[Docket No. FAA-2020-0883; Project Identifier 2019-CE-034-AD; Amendment 39-21460; AD 2021-05-17]

**Airworthiness Directives; Rockwell Collins, Inc. Flight Display System Application**

**ACTION:** Final rule.

Figure 1 to paragraph (g)(1)(iii); placard location on bezel

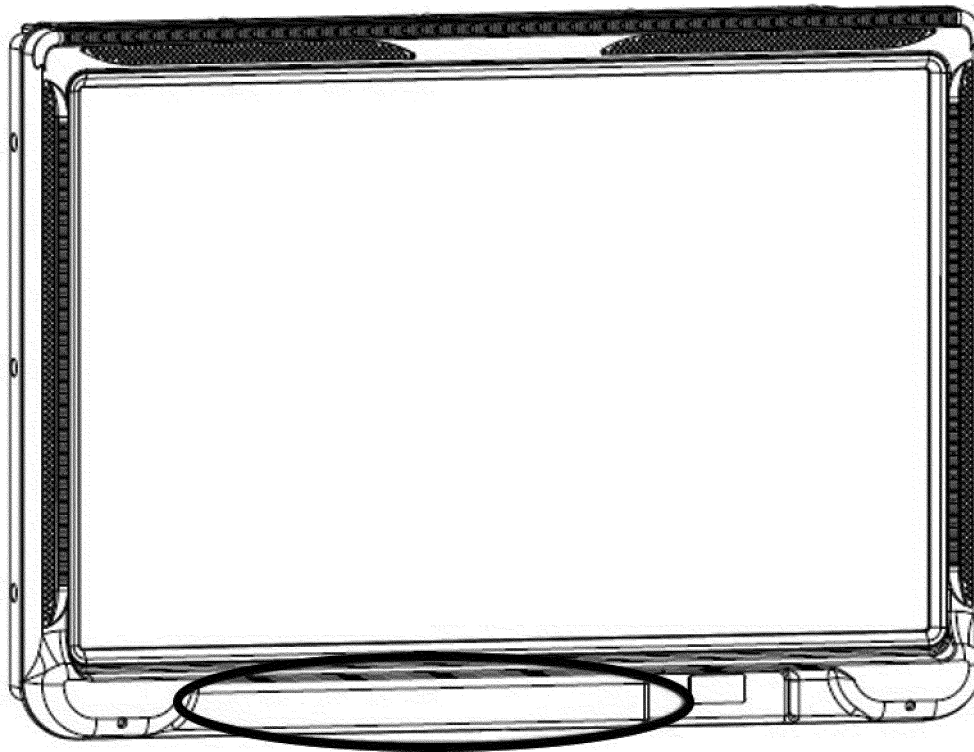
(ii) Fabricate a placard for each aircraft primary flight display, using at least 1/8 inch letters, with the following text: TCAS Flight Ops—TA Only mode (TA/RA mode prohibited).

(iii) Install the placard on the bottom of each aircraft primary flight display bezel in the area depicted in figure 1 to paragraph (g)(1)(iii) of this AD.
